Access Review

The Pittwater House Schools
70 South Creek Road, Collaroy

Report Issue 2

Accessible Paths of Travel Through the School

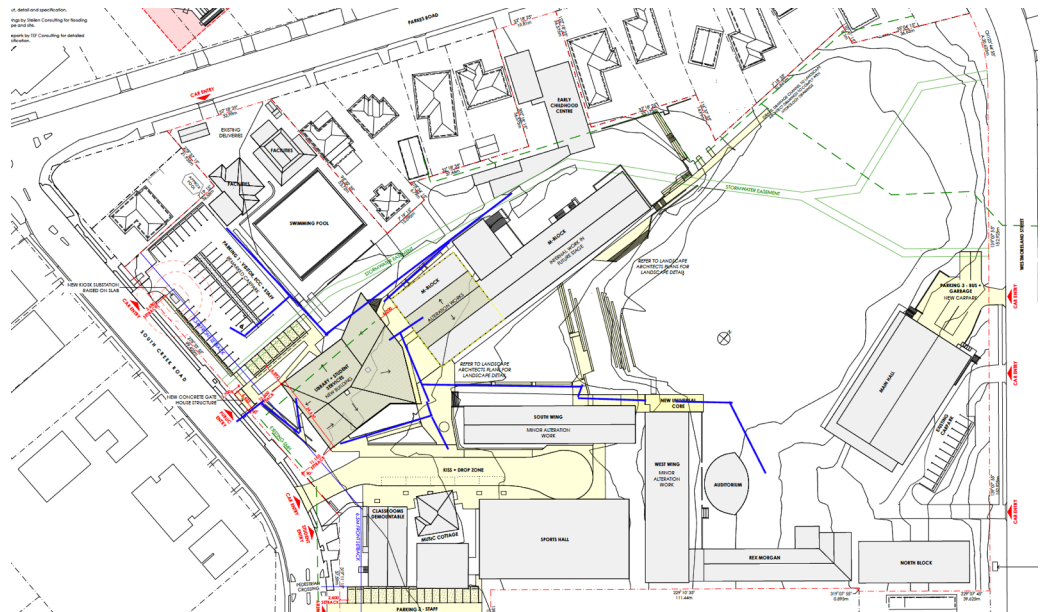
The following diagram shows the proposed provision of continuous accessible paths of travel through the school and to lifts linking all facilities and buildings.

A continuous accessible path of travel is an uninterrupted route to and within premises providing access to all features, services and facilities. It is step free and safe. A continuous accessible path of travel should extend to all amenities and areas to which the public (including employees) is entitled or allowed to enter or use.

A continuous accessible path of travel should be the most commonly used and direct path of travel. If for any reason this is not possible, clear signage of the alternative route should be provided.
